The Corporation of the Town of South Bruce Peninsula

Quotation PW 17- 21

Hepworth Park Entrance

Addendum 1

2. Page 13 of 21 – Figure 2

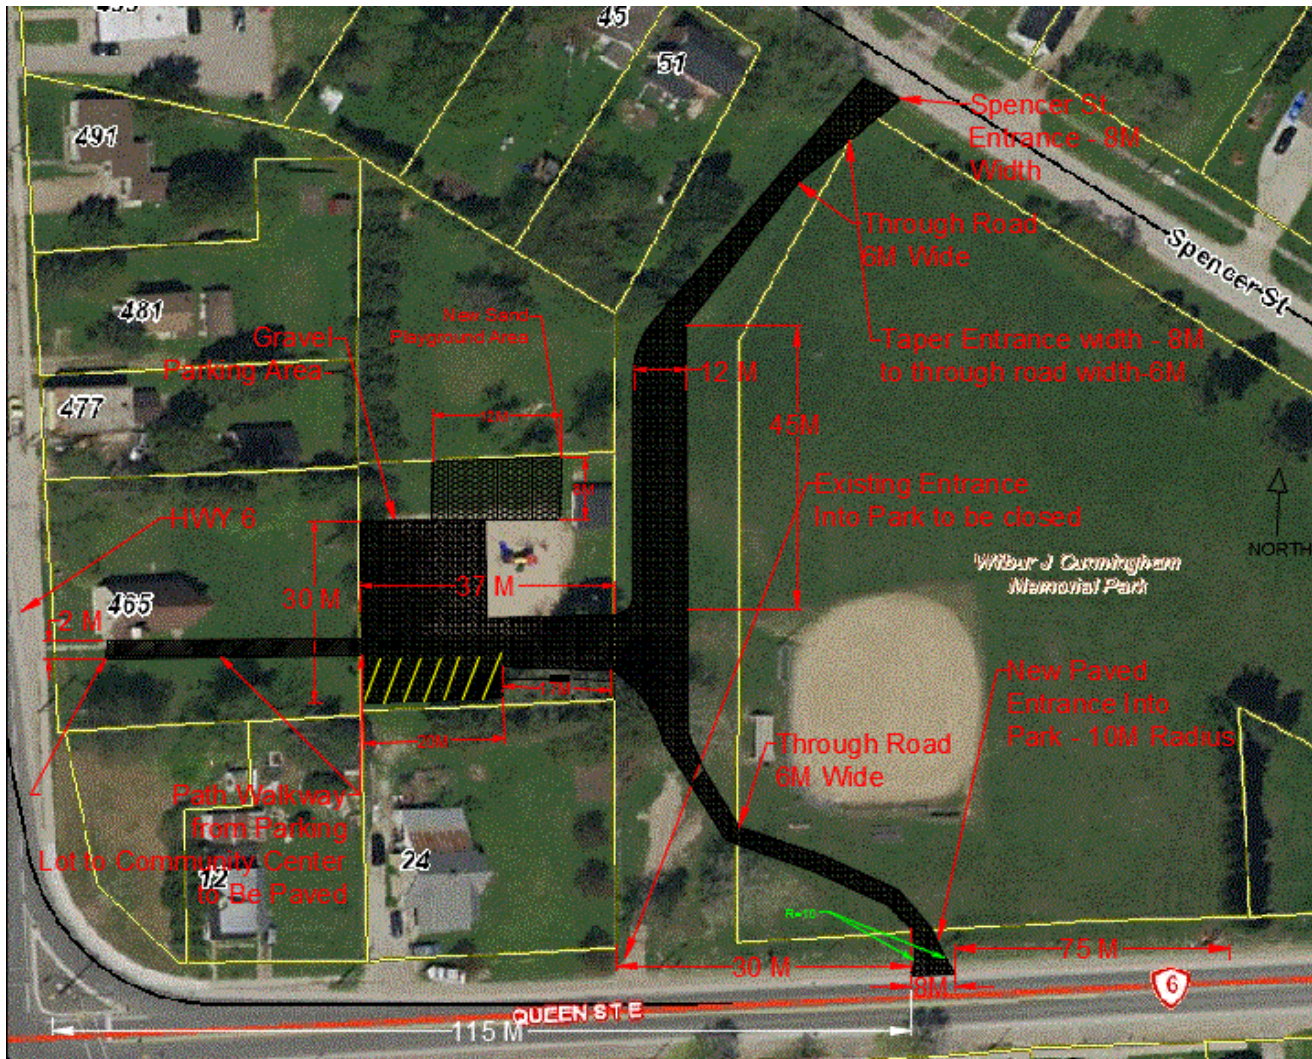
The quotation document shows the plan for the Hepworth Park in Figure 2 on page 13. The original plan shows the gravel parking lot location along the property line north of 24 Queen St E, with dimensions of 15.0 m x 37.0 m. The gravel parking lot's size and location have been changed.

Town Response: The new parking lot will run along the west side of the playground with dimensions of 30.0 m x 25.0 m. The entrance off of Queen St E has been moved 10.0 m east from the original Figure 2 drawing in the bid document. The changes to the gravel parking lot and the entrance off of Queen St E are depicted below.
